Site Plan (CSP25-345)

CSP – 2220 W FM 917

Resolution for a site plan for a QuikTrip.

Site Plan Summary:

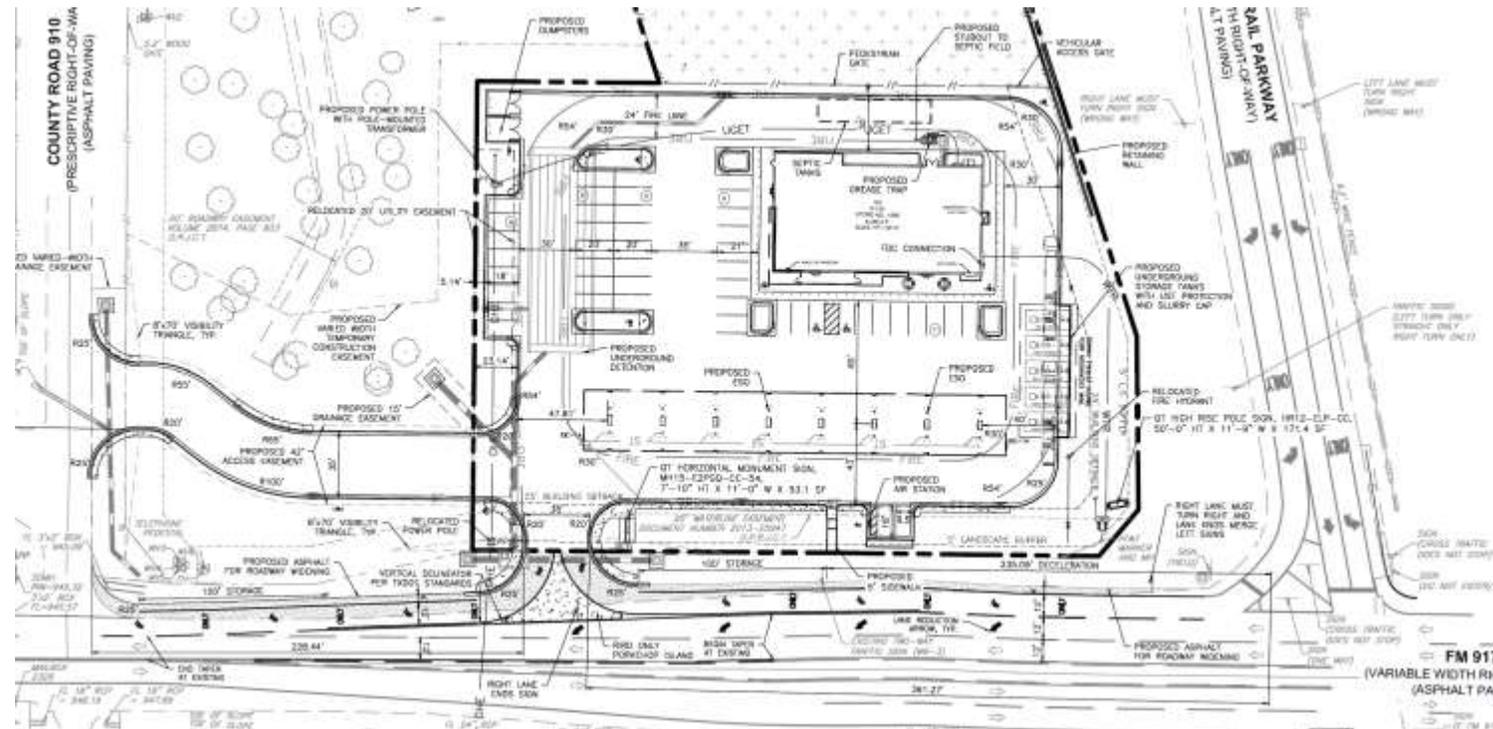
Variance(s) requested:

Driveway spacing along CR 910 (100.3 ft)

-Design Manual: 180 feet minimum (no less than 100 feet)

Landscaping

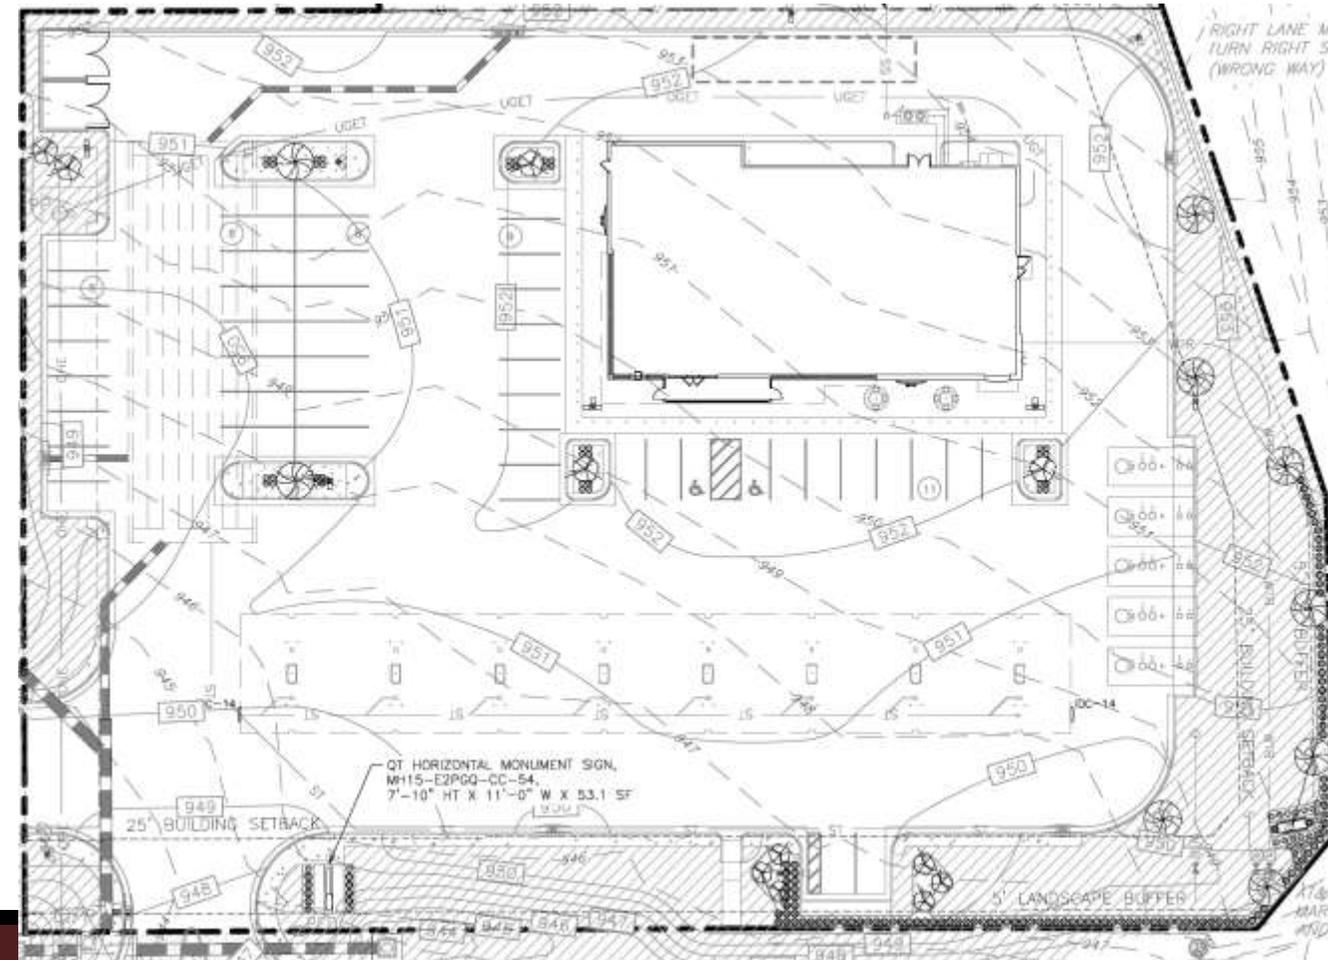
Required 16,991 SF

Providing 16,833 SF
